## RELEASE NOTES

The following documents changes/corrections to the program with each Version Release. The latest release incorporates all changes listed.

Original Schematic

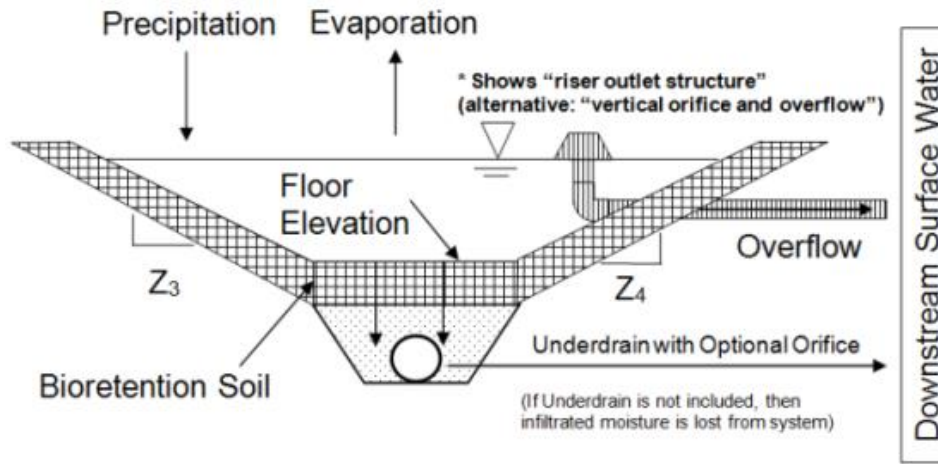
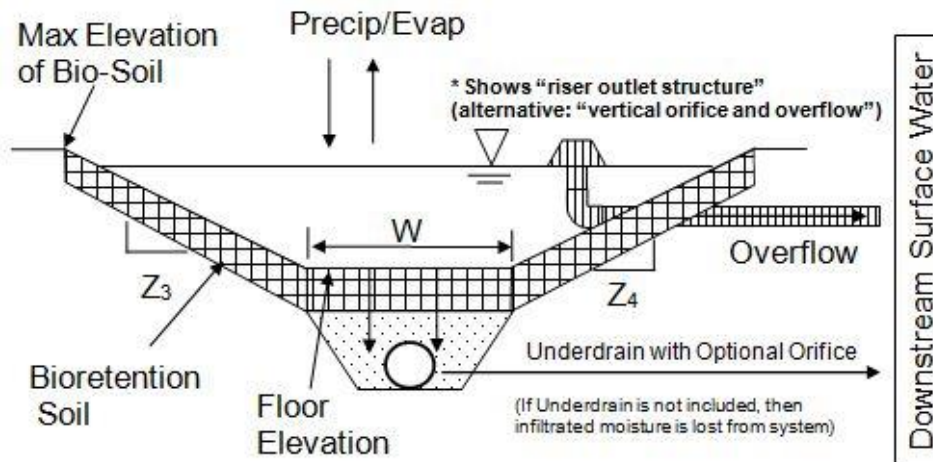
- ❖ Modified the bioretention facility routine to allow simulation of vertical side slopes, which is useful for planter simulation. New Bioretention schematic shown below.

- ❖ Changed bioretention facility so that biosoil was truncated on sides based on maximum possible water level in pond. The maximum level is determined by the elevation entered by the user.
